Addendum # 3

Bid Opportunity: 25-7706-RFT - Glenview Park Secondary School Elevator and Science

Laboratory Renovation

ADDENDUM 03

CUSTOM INDOOR AIR HANDLING UNIT SCHEDULE (PHASE 2)

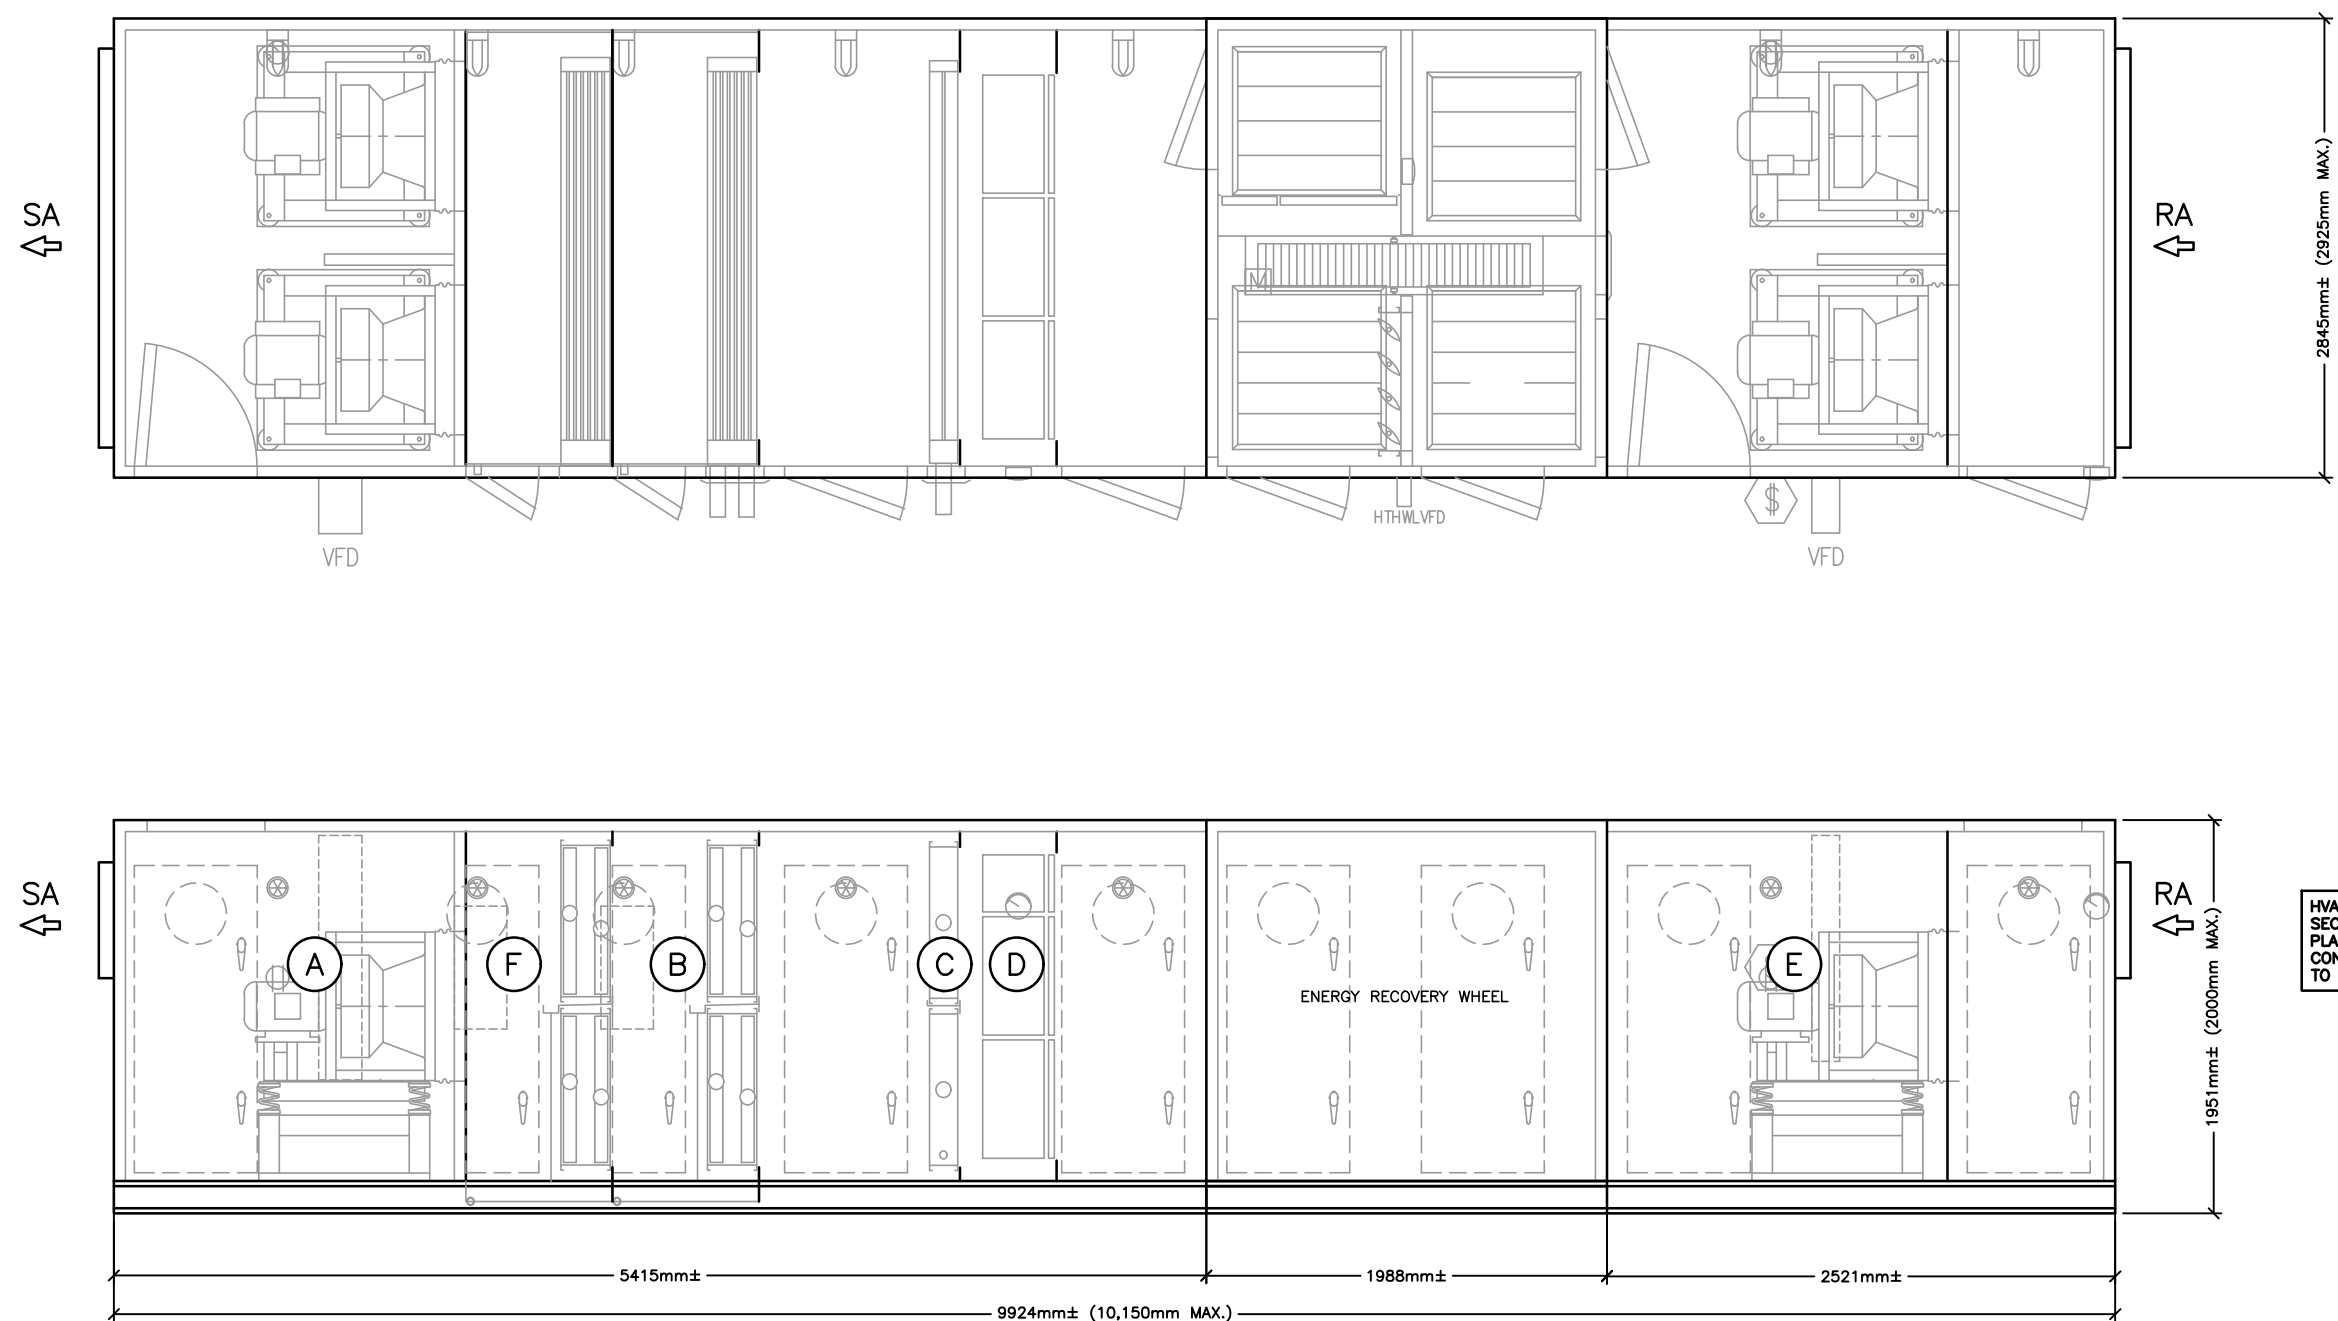
- 1.0 Reference Drawing M1.1 and Attached Sketches AD03-M01 and AD03-M02
- .1 Revise Custom Indoor Air Handling Unit Schedule (Phase 2), as per attached sketch AD03-M01.
 - .2 In Custom Indoor Air Handling Unit Schedule (Phase 2), add Haakon as base-bid manufacturer. Daikin shall be listed as an acceptable manufacturer.
 - .3 In Custom Indoor Air Handling Unit Schedule (Phase 2), add Envent as an acceptable manufacturer.
 - .4 In Custom Indoor Air Handling Unit Schedule (Phase 2), add Engineered Air as an acceptable manufacturer.
 - .5 In Pump Schedule, remove requirement for remote variable frequency drive.
 - .6 In Fan Schedule (Phase 1), revise 'EF-8' as per attached sketch AD03-M02.

ENLARGED PLANS (4
OF 4)

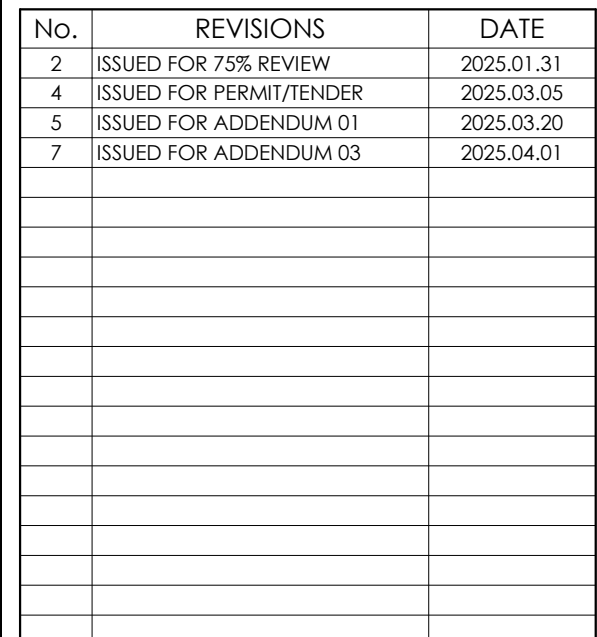
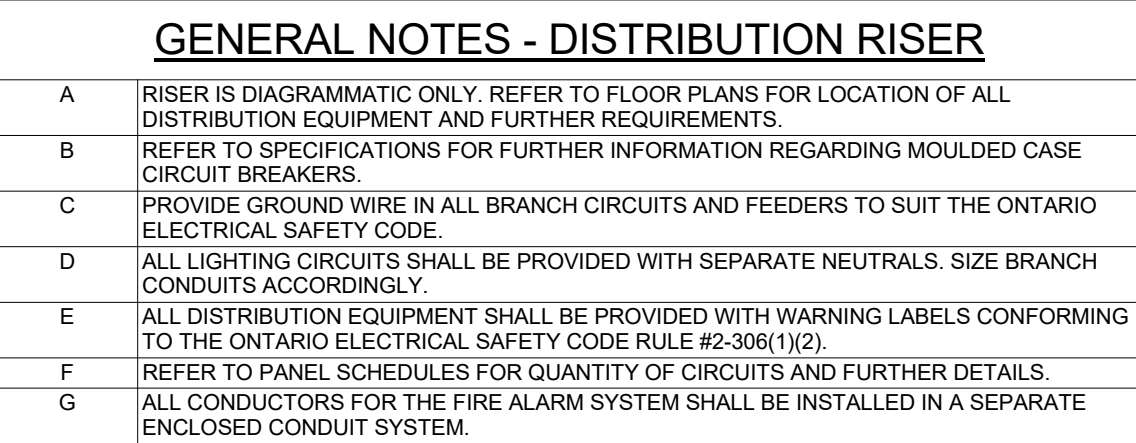
- 2.0 Reference Attached Reissued Drawing E304
- .1 HVAC supply fan (HVAC-5-SF) has been deleted as per attached reissued drawing E304.
 - .2 Two HVAC return/exhaust fan (HVAC-5-EF) have been deleted as per attached reissued drawing E304.
 - .3 HVAC energy recovery wheel (HVAC-ERW) has been deleted as per attached reissued drawing E304.
 - .4 HVAC unit controller (HVAC-5-UC) has been deleted as per attached reissued drawing E304.
 - .5 Add 208V 3PH power for indoor HVAC unit (HVAC-5) as per attached reissued drawing E304.
 - .6 Add 120V 1PH power for marine lights as per attached reissued drawing E304.
